Project	IEEE 802.16 Broadband Wireless Access Working Group < http://ieee802.org/16 >	
Title	The Passive Multi-hop Relaying HARQ Mechanism	
Date Submitted	2007-03-05	
Source(s)	Wei Ni, Gang Shen, Shan Jin Alcatel-Lucent, Research & Innovation No. 388, Ningqiao Rd., Pudong Jinqiao, Shanghai, P. R. C	Voice: 86-21-50554550 Fax: 86-21-50554554 mailto: wei.a.ni@alcatel-sbell.com.cn
	Fang Liu, Lan Chen, Xiaoming She, Daqing Gu DoCoMo Beijing Lab 7/F, Raycom Infotech Pack Tower A No.2 Kexueyuan South Rd., Haidian District, Beijing, China	Voice: +86-10-82861501 ex.331 Fax: +86-10-82861506 mailto: {liu, gu}@docomolabs-beijing.com.cn
	Fujio Watanabe DoCoMo USA Labs 3240 Hillview Avenue, Palo Alto, CA	Voice: 650-496-4726 watanabe@docomolabs-usa.com
Re:	Response to "Call for Technical Comments and Contributions regarding IEEE Project P802.16j" (IEEE 802.16j-07_007r2)	
Abstract	This document proposes a passive MR HARQ mechanism based on the multi-hop basis. This mechanism is preferable due to its simplicity. Furthermore, the cooperative relay can be implemented with it.

The Passive Multi-hop Relaying HARQ Mechanism

Figure 130jc: The passive MR HARQ mechanism

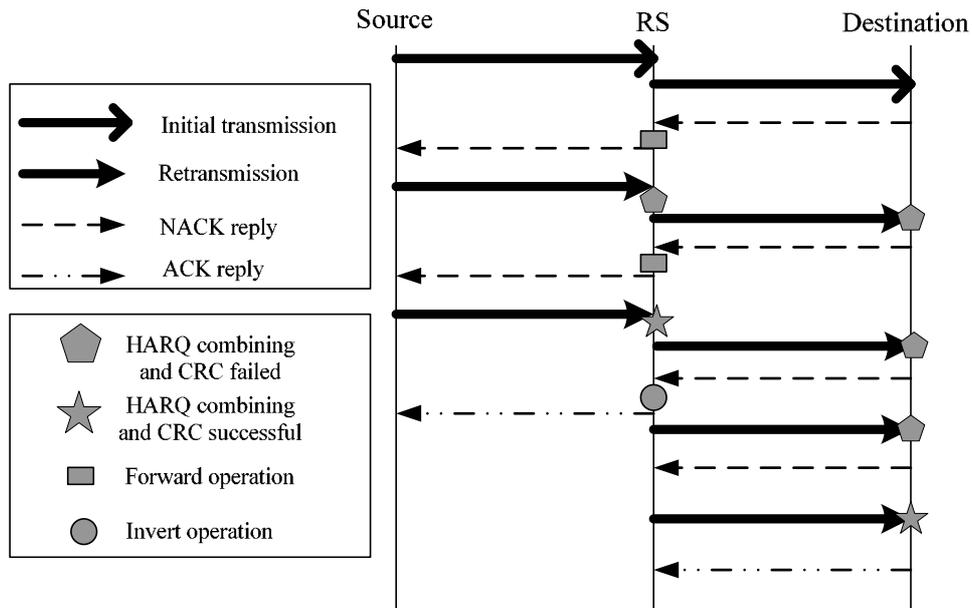
[Insert new sub-clause 6.3.17.4.2 and add figures]

Section 6.3.17.4.2 Passive MR HARQ mechanism

The passive MR HARQ is a multi-hop mechanism in which the forward is performed at the RS no matter whether the correct packet is received or not in the intermediate RS. This mechanism is dedicated for data forwarding with/without CID change along the route. Both the transparent and non-transparent relay can be supported by this passive MR HARQ mechanism.

The principle and process of the passive MR HARQ is illustrated in Figure 130jc.

In both uplink and downlink, the source transmits its packets to the RS. The RS forwards the packet to the destination. ACK is sent back to the source via hops from the destination after a fixed delay defined by HARQ_ACK_Delay for UL or DL burst which is specified in DCD message, if the received packet succeeds in the CRC verification. Otherwise, NACK signal is transmitted. Those intermediate RSs simply forward ACK/NACK replies.

Only when a NACK is received for the previous HARQ attempt or an ACK is not received properly, the retransmission is conducted by the source. The intermediate RS performs HARQ combining and CRC verification. If the combined packet passes the CRC verification, the associated RS will play the role of the source in the following HARQ retransmission attempt to send the error-free packet, and also reply ACK signal to the source. Otherwise, the combined packet is forwarded to the next hop for Chase Combining, and the original received HARQ retransmission or the combined packet is forwarded to the next hop for Incremental Redundancy.
